Your Ref
Y/93/14/OUT
Our Ref
PLAN-008198
Date
19/12/2014

Proposal: Outline Application with some matters reserved for the erection of 40 No. dwellings each with a garage(s) and/or parking space(s), together with the means of access off North End Road.

Site: Land North of Yapton C of E Primary School, North End Road, Yapton, BN18 0DU.

Southern Water MapGuide Browser

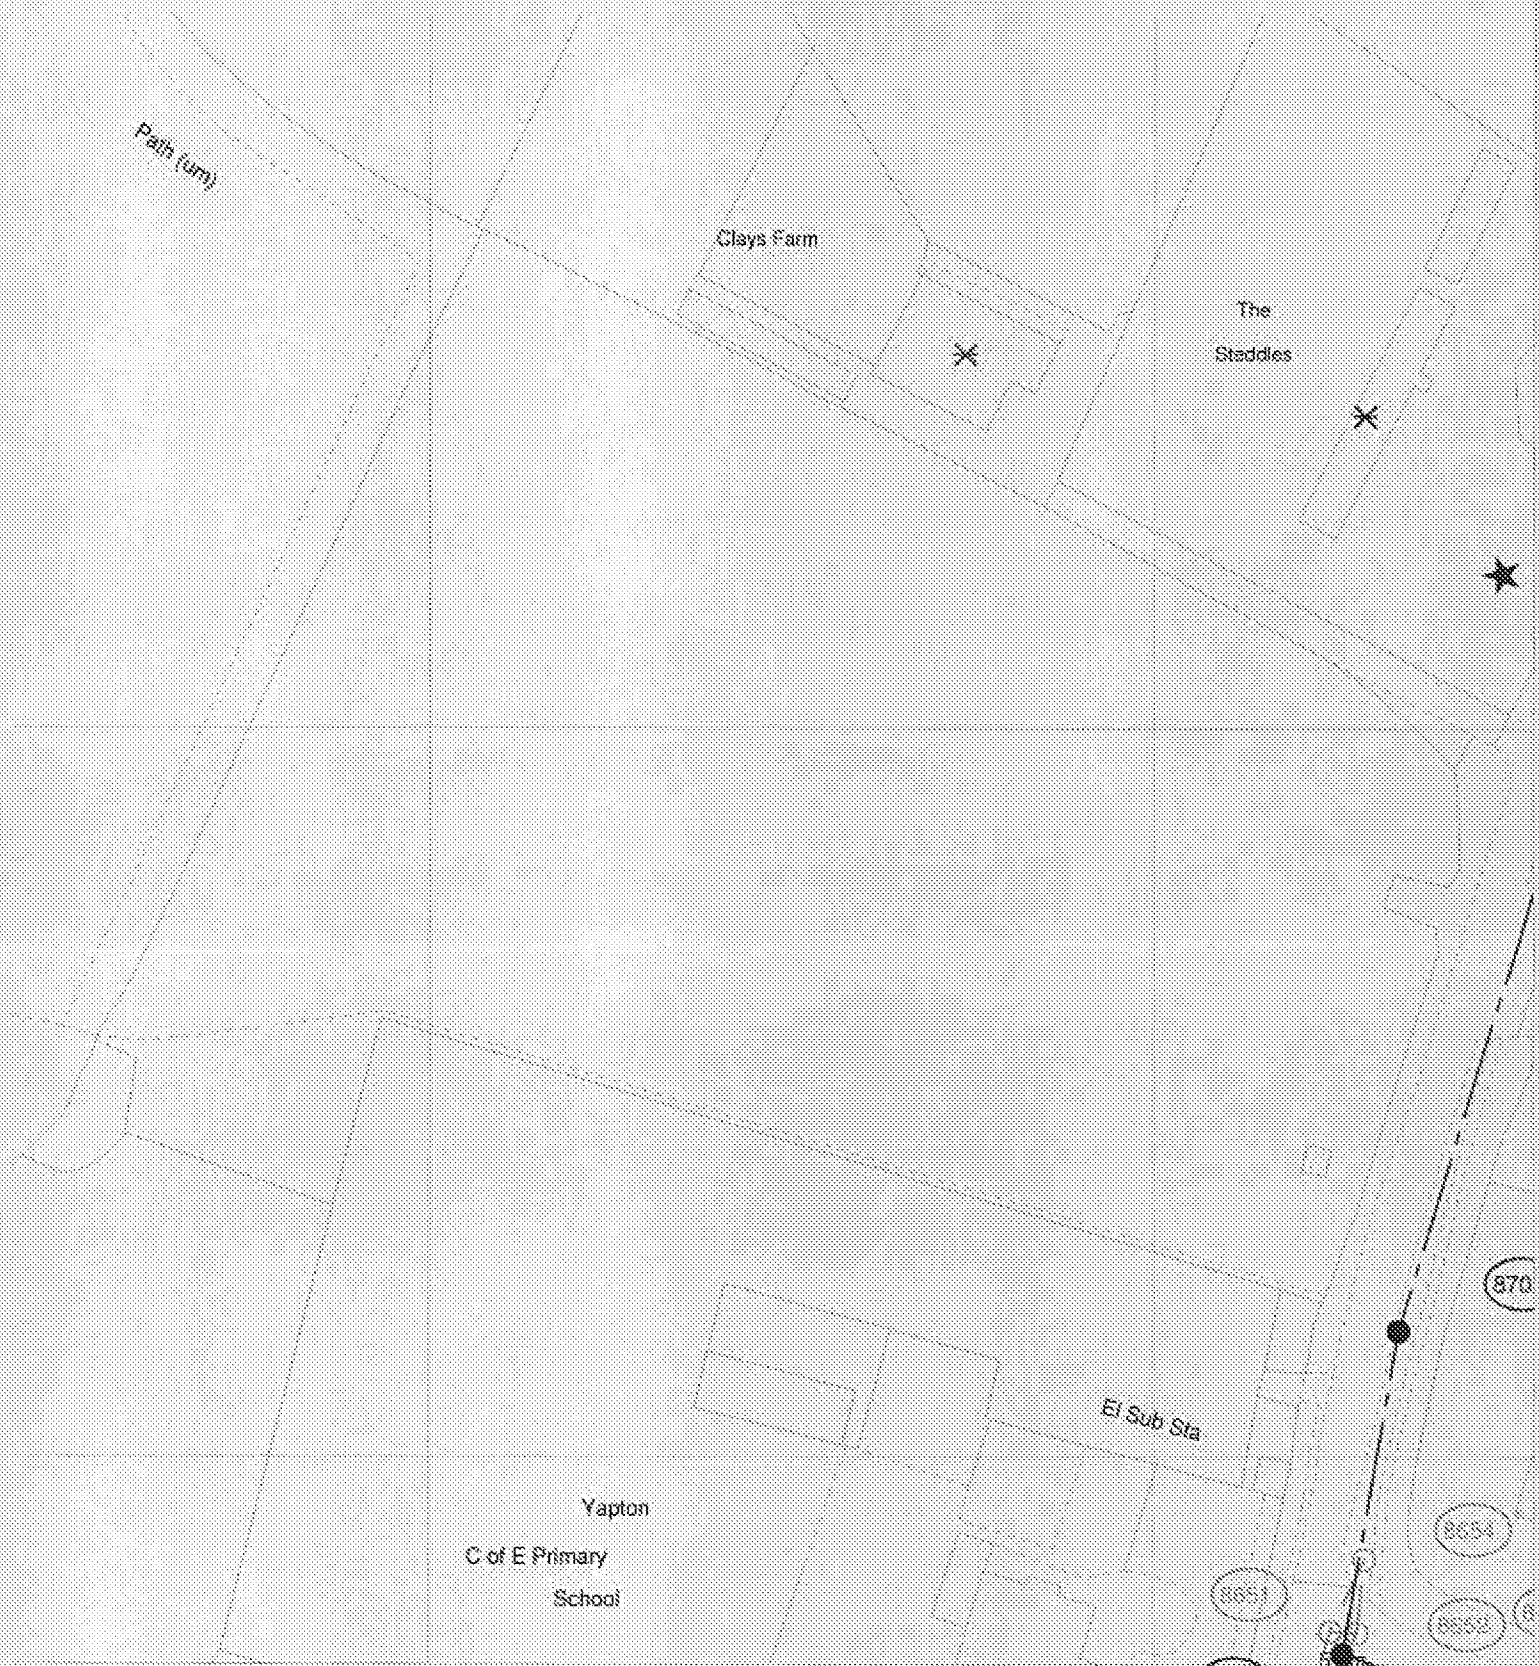
Due to changes in legislation that came in to force on 1st October 2011 regarding the future ownership of sewers it is possible that a sewer now deemed to be public could be crossing the above property. Therefore, should any sewer be found during construction works, an investigation of the sewer will be required to ascertain its condition, the number of properties served, and potential means of access before any further works commence on site.

The positions of pipes shown on this plan are believed to be correct, but Southern Water Services Ltd accept no responsibility in the event of inaccuracy. The actual positions should be determined on site.

The applicant is advised to discuss the matter further with Southern Water, Sparrowgrove House, Sparrowgrove, Otterbourne, Hampshire SO21 2SW (Tel: 0330 303 0119) or www.southernwater.co.uk.
